Service Bulletin

Subject: Wiper Squeak or Squeal Noise During Operation

Models: 2011-2015 Chevrolet Cruze

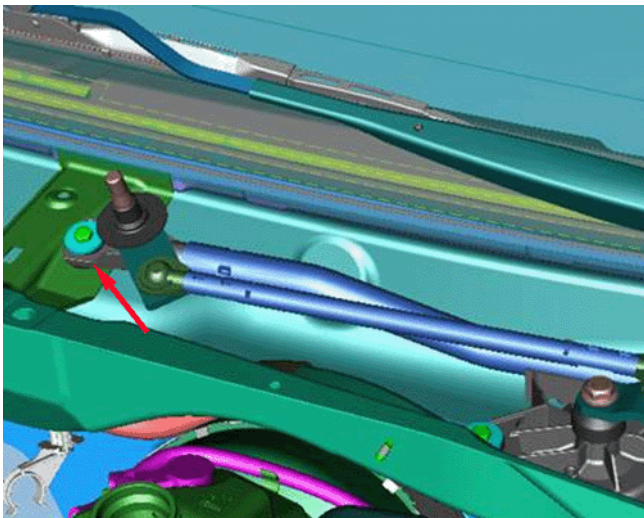
Some customers may comment on a squeak or squeal noise during wiper operation.

This condition may be caused by the passenger side wiper arm coming into contact with the windshield.

Use the following steps to increase the gap between the wiper arm and the windshield by installing a shim (such as a washer) between the wiper module and the passenger side mount bracket.

The recommended gap should be 2 to 4 mm (0.08" to 0.16").

2. Install two washers, Kent Industries Part# 98983 or the equivalent, between the wiper module and the passenger side body mount bracket as shown above.
